RE: LWSD Comments on Draft Supplemental Environmental Impact Statement for the NE 85th Street Station Area Plan and Planned Action

Kirkland NE 85th St Station Area Plan and Planned Action
Draft Supplemental Environmental Impact Statement
January 2021

Re: NE 85th Street Station Area Plan (SAP) – EIS Comments

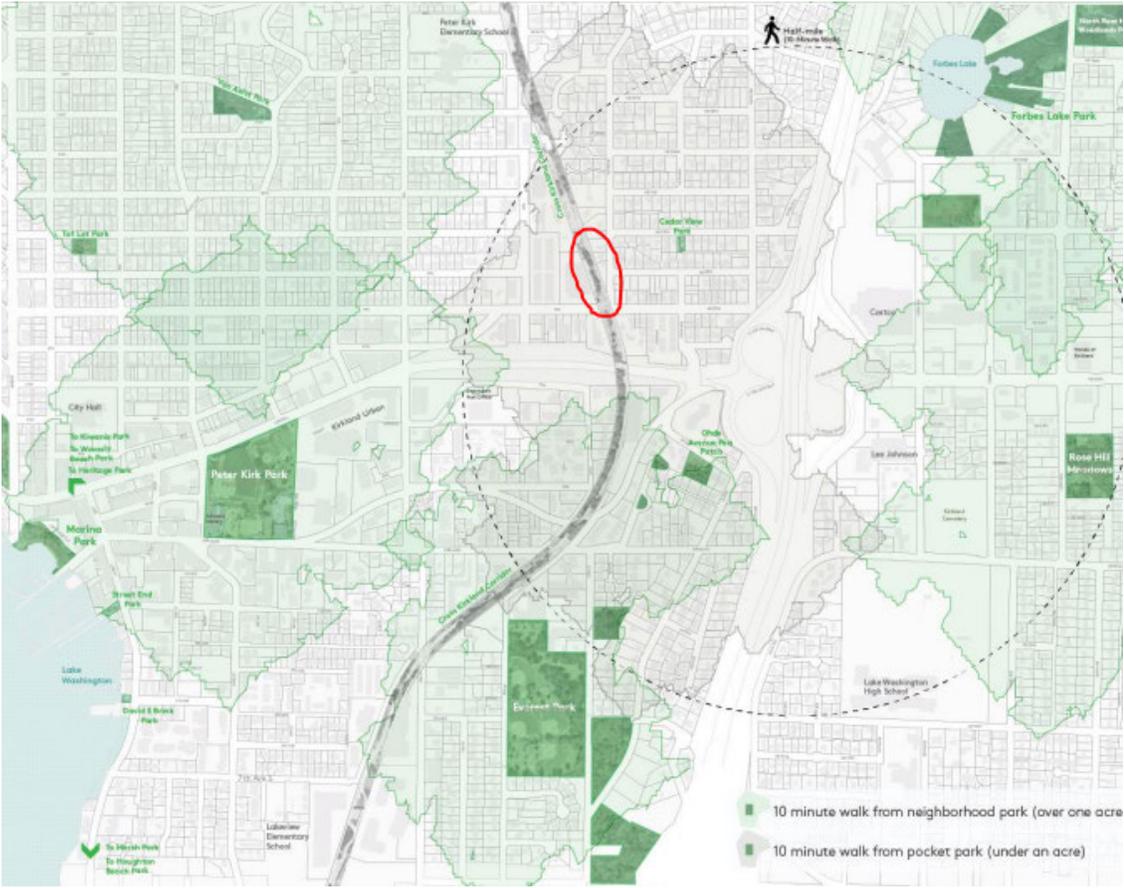
1. we have some concern on the building height planning for those area.

45Ft is ok for the builder down the hill new downtown area. but for the build such as mcleod autobody or paint sundries solution, they are at uphill. if that build changed to 45 ft. I'm afraid our lake view will be blocked(because we can't reconstruct our house, although the planning also increase the height limit). please double check on that.

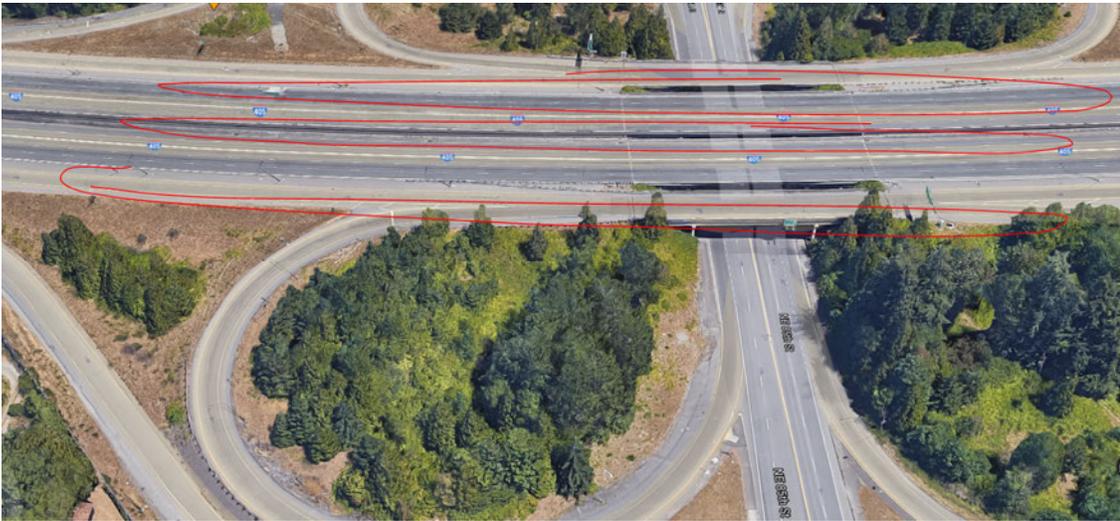
Could you please consider to change this red circle area into a public park? currently, here has some open space and has high pedestrian traffic, as you can see, highlander area are lacking of open spaces. A park with slide or zipline should be ideal to this park. Currently, this place are badly planned.
